Contract #: 04-0120F4Cty: SF/ALA Rte: 80 PM: 13.2/13.9File #: 69.25B**QUALITY ASSURANCE -- NON-CONFORMANCE REPORT****Location:** Changxing Island, Shanghai, P.R. China**Report No:** NCR-000477**Prime Contractor:** American Bridge/Fluor Enterprises, a JV**Date:** 14-Oct-2009**Submitting Contractor:** Zhenhua Port Machinery Company, Ltd (ZPMC), Changxing Island**NCR #:** ZPMC-0450**Type of problem:****Welding****Concrete****Other****Welding****Curing****Procedural****Bridge No:** 34-0006**Joint fit-up****Coating****Other****Component:** OBG Segment 6CE Deck Plate Stiffener Weld Joint**Procedural****Procedural****Description:** Missed MT indication by QC and Repair without CWR**Reference Description:** Missed MT Indications by QC on Segment 6CE and weld repair without CWR**Description of Non-Conformance:**

Job Name: SAS Superstructure

Subject: NCR No. ZPMC-0450

Reference Description: Missed MT Indications by QC on Segment 6CE and weld repair without CWR

Joint fit-up Coating Other **Component:** OBG Segment 6CE Deck Plate Stiffener Weld Joint

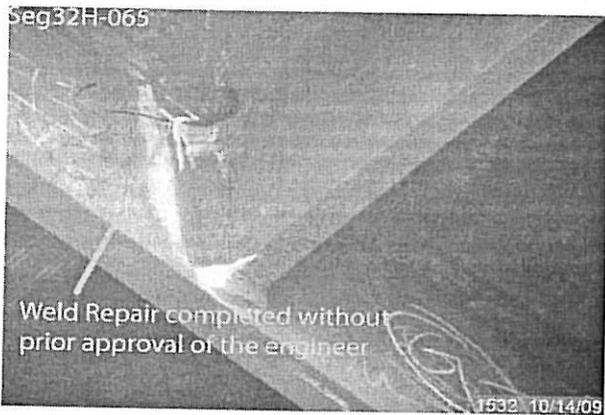
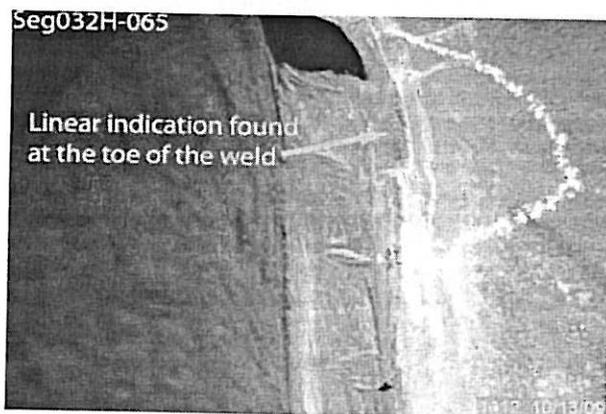
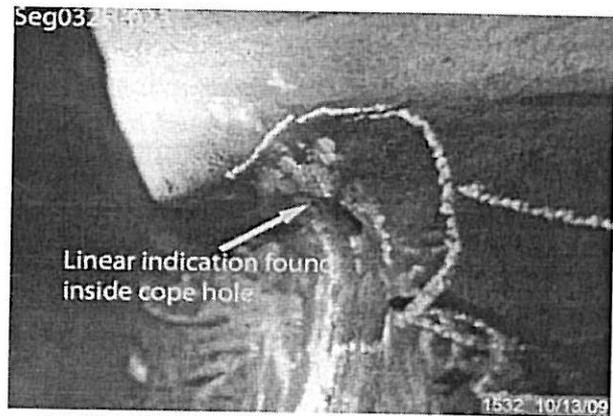
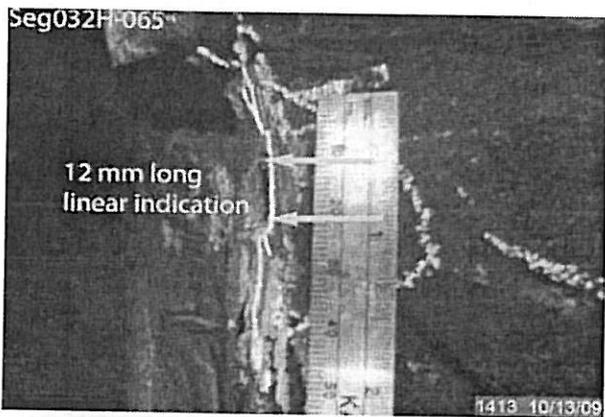
During a random verification of Magnetic Particle (MT) Testing of the OBG Segment 6CE welds, Caltrans Quality Assurance (QA) inspector discovered a total three (3) linear indications approximately 12mm to 20mm in length located at welds SEG32H-065, 123 and 023. These welds have been previously tested and accepted by ZPMC Quality Control MT technicians. Also, ZPMC personnel completed these weld repairs without prior Engineer approval or utilizing an approved critical weld repair procedure (CWR).

项目名称 Project Name:	美国海湾大桥 SFOBB	部件图号 Drawing No.:	SEG032H	报告编号 Report No.:	B-CWR1329
合同号 Contract No.:	04-0120F4	部件名称 Item Name:	6CE CORNER ASSE MBLY	NDT 报告编号 NDT Report No.:	B787-MT-20555
项目编号 Project No.:	ZP06-787

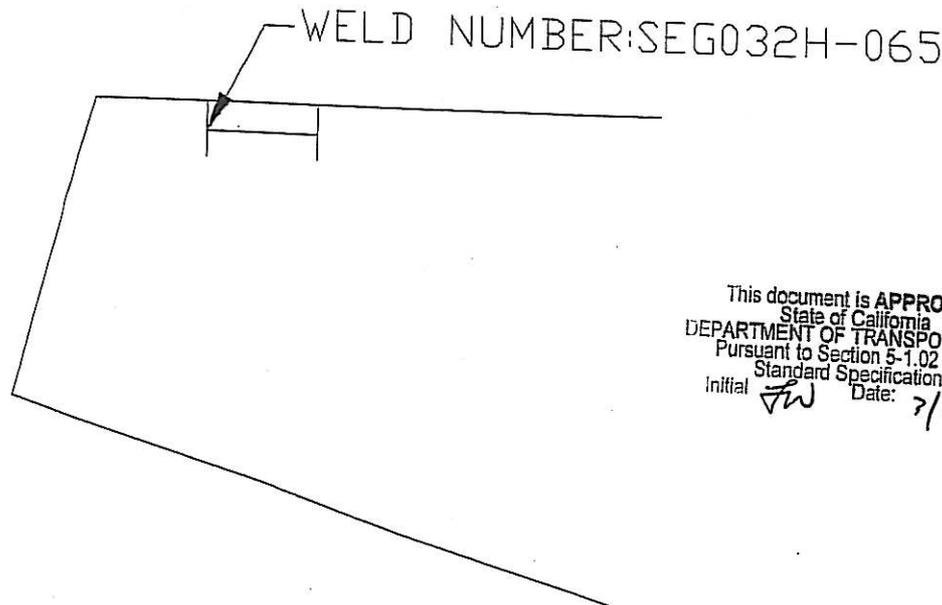
Description of Welding Discontinuity:
在对SEG032H-065检测时, 发现1处纵向裂纹。1、L=12mm.

One longitudinal crack was found by use of MT on SEG032H-065.

1. QC and a Lead CWI shall be present, direct and supervise all grinding and welding operations during this repair to ensure the repair is per the disposition requirements

2. QC and a Lead CWI shall have an approved copy of the CWR in hand prior to the repair.
3. Remove paint $\geq 25\text{mm}$ in all direction of HAZ prior to MT.

4. Clean the excavation area of all loose debris including MT powder. Preheat to 65° C before removing cracks by grinding, repair area shall extend a minimum of 50mm beyond each end of single crack repairs.

5. If base metal is damaged by grinding, the damaged area shall be ground clean prior to performing weld repair. If gap $> 5\text{mm}$ is found during or after grinding, comply with the notification on changing fillet weld to CJP which is submitted for Engineer's review and approval form.

6. Prepare excavation in accordance with the New Repair Procedure prior to welding.
7. Before this repair, Verify with VT and MT repair areas are defects free, and also MT shall be performed on the base metal laying abroad cracks to ensure that no cracks were propagated to the base metal. Separate CWR approval is needed if cracks are found in the base metal, and only after this new CWR's approval can continue the repair.

8. Clean excavation area of all loose debris including MT powder after excavation. Preheat and weld according to repair WPS, the preheat shall between 160° C-230° C

9. Perform post weld heating according to repair WPS, the postheat shall between 230° C-315° C and for one hour minimum.
10. Allow the weld to cool to ambient temperature gradually. Control cooling rate after PWHT to no more than 50° C per hour.

11. Grind the repaired area flush with base metal or the adjacent weld after post weld heating.
12. Wait 48 hours at least after the repair area has cooled to ambient temperature before performing NDT.

13. Perform MT inspection to all repair area according to Contract Drawings along with all additional NDT required by the applicable notes Special Provision Section 10-1.59 'Steel Structure', subsection 'inspection testing'. NDT include VT, MT and UT if it is a CJP weld.

项目名称 Project Name:	美国海湾大桥 SFOBE	部件图号 Drawing No.:	SEG032H	报告编号 Report No.:	B-CWR132E
合同号 Contract No.:	04-0120F4	部件名称 Item Name:	6CE CORNER ASSE MBLY	NDT 报告编号 NDT Report No.:	B787-MT-20554
项目编号 Project No.:	ZP06-787

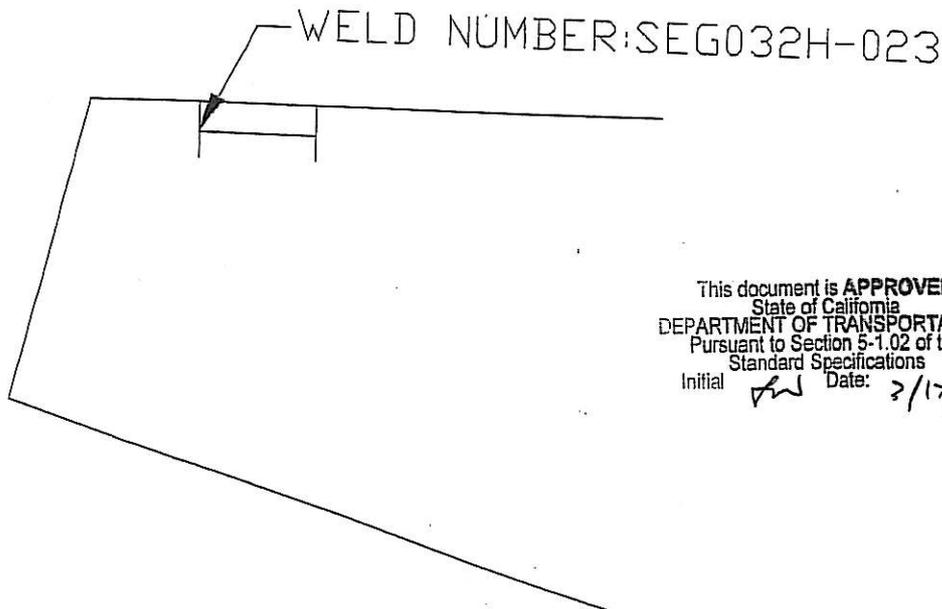
在对SEG032H-023检测时, 发现1处纵向裂纹。1、L=20mm

One longitudinal crack was found by use of MT on SEG032H-023.

1. QC and a Lead CWI shall be present, direct and supervise all grinding and welding operations during this repair to ensure the repair is per the disposition requirements

2. QC and a Lead CWI shall have an approved copy of the CWR in hand prior to the repair.
3. Remove paint $\geq 25\text{mm}$ in all direction of HAZ prior to MT.

4. Clean the excavation area of all loose debris including MT powder. Preheat to 65° C before removing cracks by grinding, repair area shall extend a minimum of 50mm beyond each end of single crack repairs.

5. If base metal is damaged by grinding, the damaged area shall be ground clean prior to performing weld repair. If gap $> 5\text{mm}$ is found during or after grinding, comply with the notification on changing fillet weld to CJP which is submitted for Engineer's review and approval form.

6. Prepare excavation in accordance with the New Repair Procedure prior to welding.
7. Before this repair, Verify with VT and MT repair areas are defects free, and also MT shall be performed on the base metal laying abroad cracks to ensure that no cracks were propagated to the base metal. Separate CWR approval is needed if cracks are found in the base metal, and only after this new CWR's approval can continue the repair.

8. Clean excavation area of all loose debris including MT powder after excavation. Preheat and weld according to repair WPS, the preheat shall between 160° C-230° C.

9. Perform post weld heating according to repair WPS, the postheat shall between 230° C-315° C and for one hour minimum.
10. Allow the weld to cool to ambient temperature gradually. Control cooling rate after PWHT to no more than 50° C per hour.

11. Grind the repaired area flush with base metal or the adjacent weld after post weld heating.
12. Wait 48 hours at least after the repair area has cooled to ambient temperature before performing NDT.

13. Perform MT inspection to all repair area according to Contract Drawings along with all additional NDT required by the applicable notes Special Provision Section 10-1.59 'Steel Structure', subsection 'inspection testing'. NDT include VT, MT and UT if it is a CJP weld.

关键焊缝返修报告 Critical Welding Repair Report (CWR)			版本 Rev. No.:
					0
项目名称 Project Name:	美国海湾大桥 SFOBB	部件图号 Drawing No.:	SEG032H	报告编号 Report No.:	B-CWR1330
合同号 Contract No.:	04-0120F4	部件名称 Item Name:	6CE CORNER ASSE MBLV	NDT 报告编号 NDT Report No.:	B787-MT-20556
项目编号 Project No.:	ZP06-787

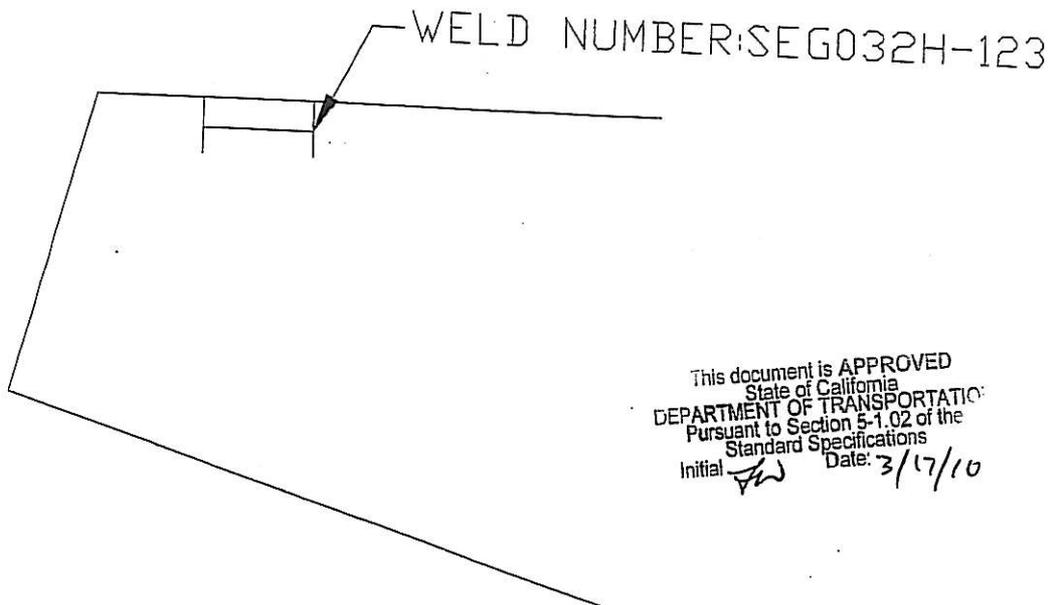
在对SEG032H-123检测时, 发现1处纵向裂纹。1、L=15mm.

One longitudinal crack was found by use of MT on SEG032H-123.

1. QC and a Lead CWI shall be present, direct and supervise all grinding and welding operations during this repair to ensure the repair is per the disposition requirements

2. QC and a Lead CWI shall have an approved copy of the CWR in hand prior to the repair.
3. Remove paint ≥ 25mm in all direction of HAZ prior to MT.
4. Clean the excavation area of all loose debris including MT powder. Preheat to 65° C before removing cracks by grinding, repair area shall extend a minimum of 50mm beyond each end of single crack repairs.

5. If base metal is damaged by grinding, the damaged area shall be ground clean prior to performing weld repair. If gap > 5mm is found during or after grinding, comply with the notification on changing fillet weld to CJP which is submitted for Engineer's review and approval form.

6. Prepare excavation in accordance with the New Repair Procedure prior to welding.
7. Before this repair, Verify with VT and MT repair areas are defects free, and also MT shall be performed on the base metal laying abroad cracks to ensure that no cracks were propagated to the base metal. Separate CWR approval is needed if cracks are found in the base metal, and only after this new CWR's approval can continue the repair.

8. Clean excavation area of all loose debris including MT powder after excavation. Preheat and weld according to repair WPS, the preheat shall between 160° C-230° C.

9. Perform post weld heating according to repair WPS, the postheat shall between 230° C-315° C and for one hour minimum.
10. Allow the weld to cool to ambient temperature gradually. Control cooling rate after PWHT to no more than 50° C per hour.

11. Grind the repaired area flush with base metal or the adjacent weld after post weld heating.
12. Wait 48 hours at least after the repair area has cooled to ambient temperature before performing NDT.

13. Perform MT inspection to all repair area according to Contract Drawings along with all additional NDT required by the applicable notes Special Provision Section 10-1.59 'Steel Structure', subsection 'inspection testing'. NDT include VT, MT and UT if it is a CJP weld.
